SUNDRY NOTICES AND REPORTS ON WELLS

Atlantic Fruitland 26#2

Propose to change casing program from a cased hole completion to a open hole completion. Revised Drilling Plan attached.

DRILLING PLAN

Exhibit #1A
BOP Stack Arrangement
Open-Hole Completion Rig Operations

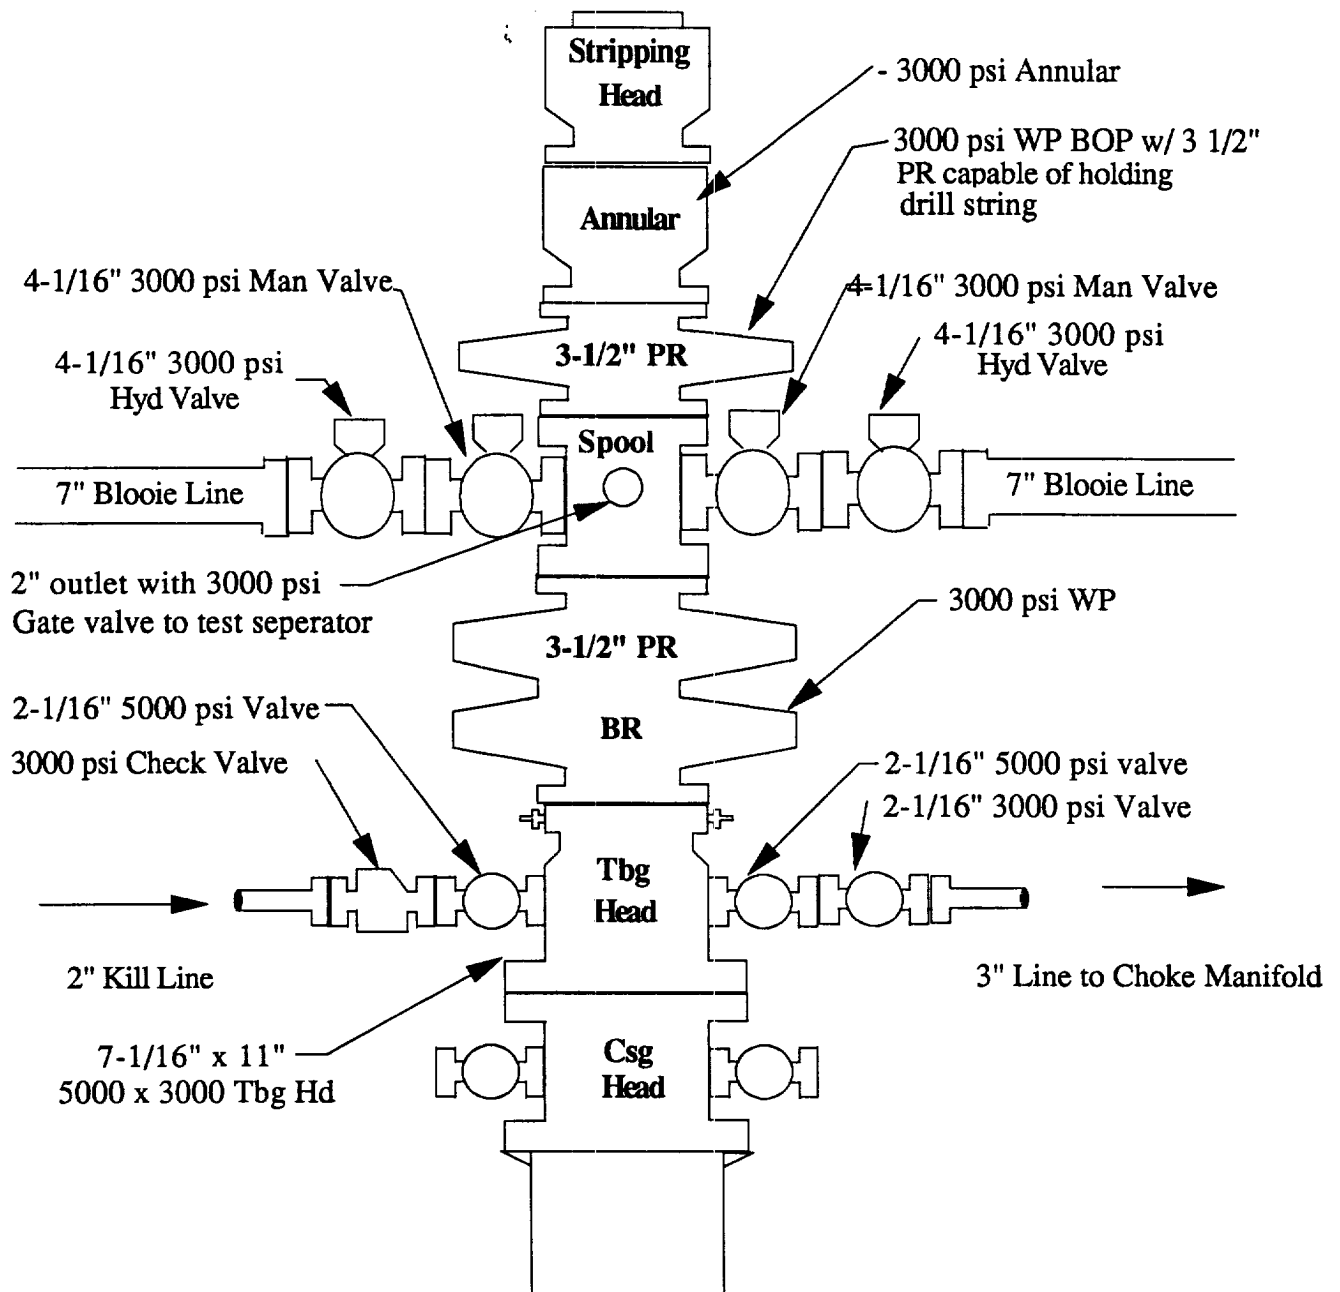
D. The well is planned to be completed Open-Hole style. The Fruitland will be drilled out from under 7" Casing using a Completion Rig and utilizing water as the drill fluid. After reaching TD, air will be added to the water to induce gas/water flow from the coal. Should wellbore stability be a problem, a 5-1/2" liner will be run to TD with 100' overlap across the 7" casing. The liner will not be cemented but will be perforated.

The maximum anticipated Fruitland pore pressure is 1500 psi. The Fruitland will be drilled out under balanced approximately 300 psi. A completion rig will be utilized for this operation using the BOP equipment specified in Exhibit #1A & #2A. There are no other abnormal pressures, temperatures or potential hazards in the area.
